April 25, 2014 Responses of BME Associates
to comments received on the
Wilmot Casino and Resort Development Plan

**Re: Wilmot Casino & Resort Development Plan
Response to Comments**

PROJECT NUMBER: 2392
 DRAWING TITLE: CIRCULATION PLAN (1 OF 2)

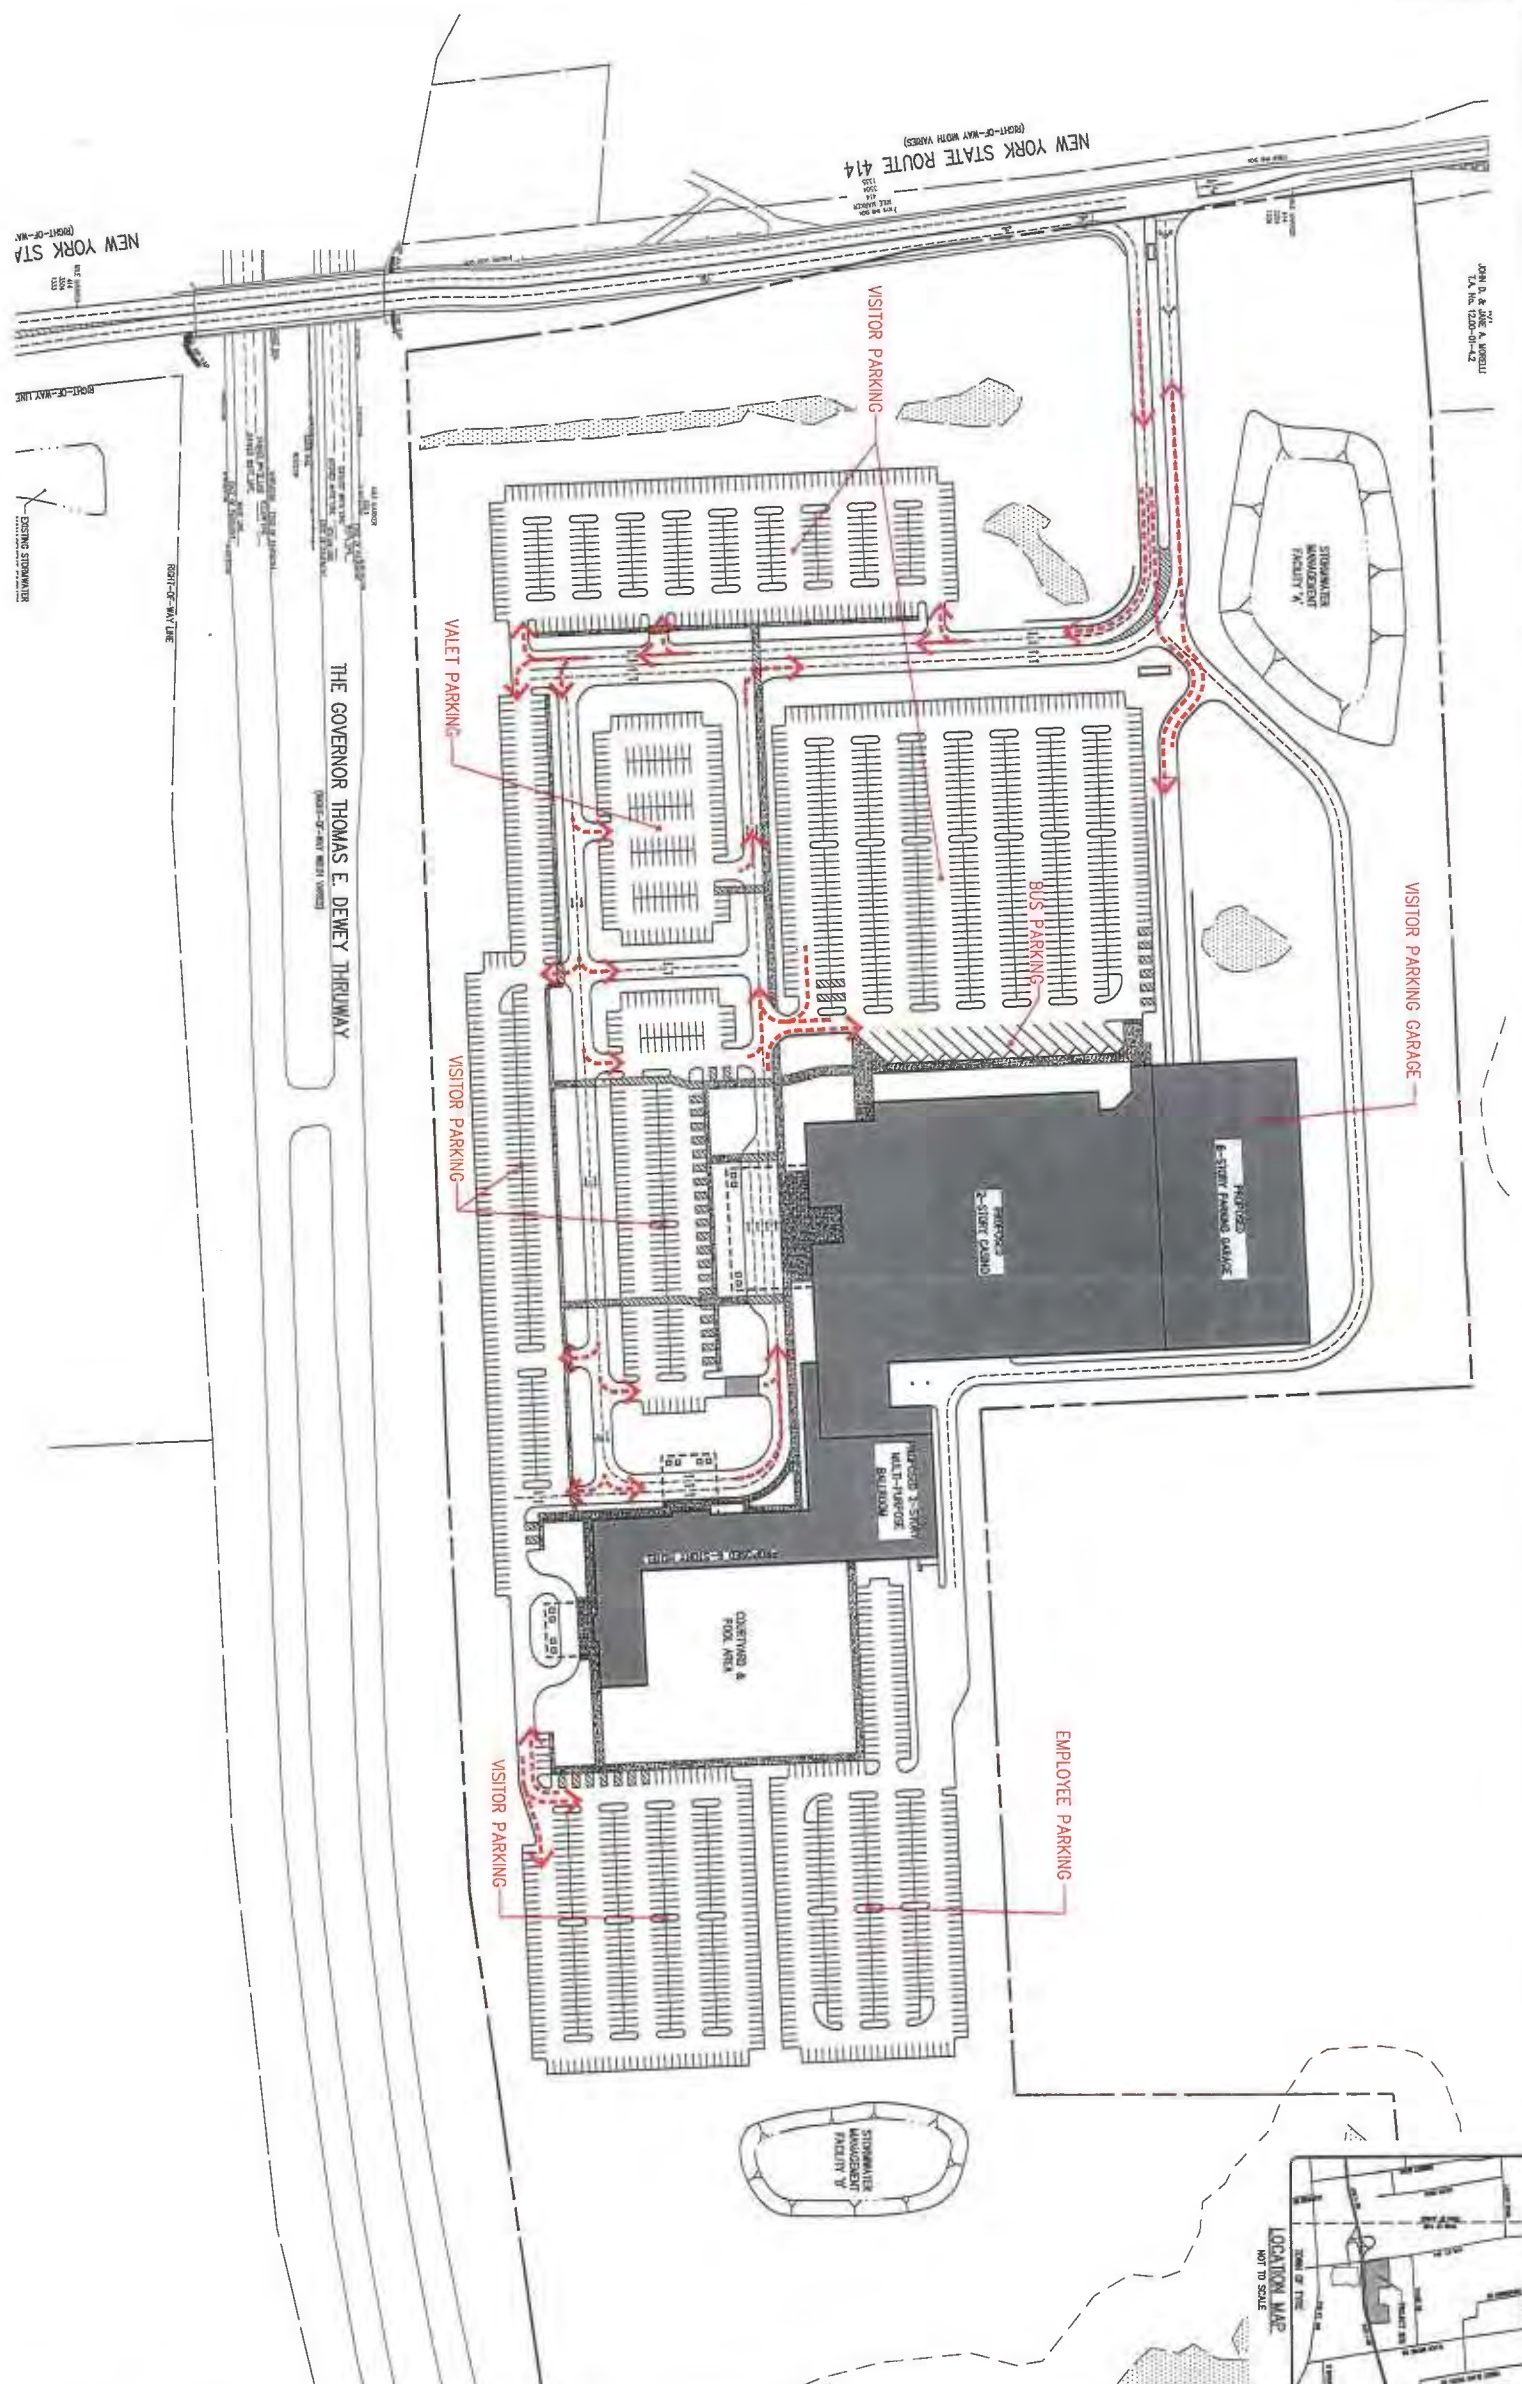
3. A circulation plan for all traffic (visitor, busses, deliveries, etc.) should be provided for review. Turning templates depicting larger vehicle movements (trucks, busses, etc.) should be provided for review.

Two circulation plans have been provided with this letter for review. The first shows the paths for deliveries, employees, and the bus routes within the site. The second shows the traffic paths for visitors within the site.
